SUBJECT: FOREIGN TRAVEL TRIP REPORT—(NON-PROPRIETARY VERSION)
NRC STAFF VISIT TO WINTERTHUR, SWITZERLAND, TO OBSERVE
SUMP STRAINER TESTING PERFORMED BY CONTROL
COMPONENTS, INCORPORATED

NRC Staff Visit to Winterthur, Switzerland, to Observe Sump Strainer Testing Performed by Control Components, Incorporated

Figure 2: Schematic Diagram of the CCI Large-Scale Test Tank

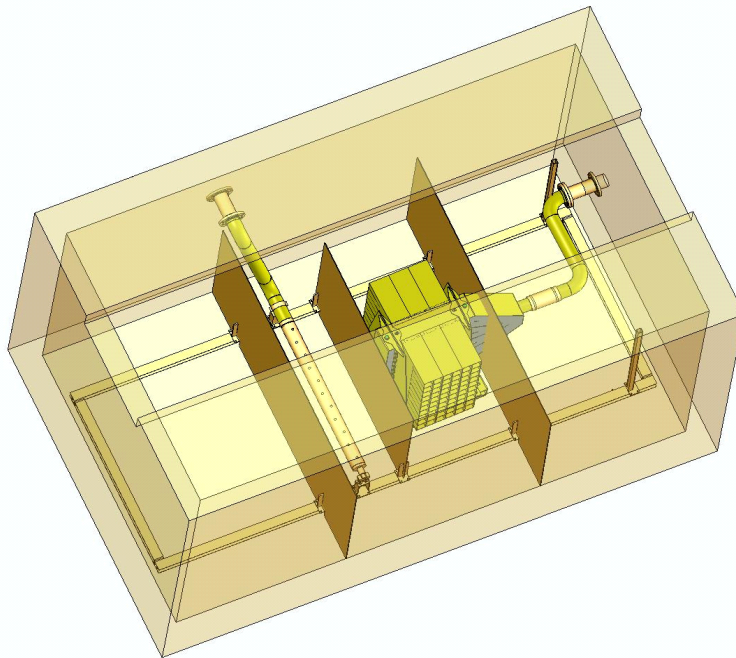
A schematic diagram of the test module in the large-scale test tank is provided as Figure 2. The large-scale test tank at CCI measures approximately 14 ft long, 9 ft wide, and 7 ft deep. As depicted in Figure 2, CCI used baffle plates and the pump discharge line to discourage the settling of debris away from the test module. The staff observed that the design of the discharge line created significant turbulence in the baffled region adjacent to the test module; however, the intervening baffle plate prevented this turbulence from significantly disturbing the establishment of laminar flow along the approach to the strainer pockets.

From observations made during the test, the staff was not able to estimate to what extent the debris that settled in front of the strainer resulted from phenomena prototypical of PWR replacement strainers (e.g., low laminar flow velocities at the face of the test module), to what extent it resulted from the nonprototypical agglomeration of debris added to the tank, and to what extent it resulted from the slumping of the debris bed after the completion of the test and the draining of the test tank.

- Ensuring that crediting of debris settling during tests is based upon prototypical conditions. Although CCI made substantial efforts to ensure that debris did not settle away from the test module, the staff considered agglomeration-induced settling of highly concentrated debris as having significant potential to affect the test results in a nonconservative manner. After this issue was raised to CCI representatives, a procedural change to mix additional water into the debris being added to the tank appeared to reduce the magnitude of this effect.
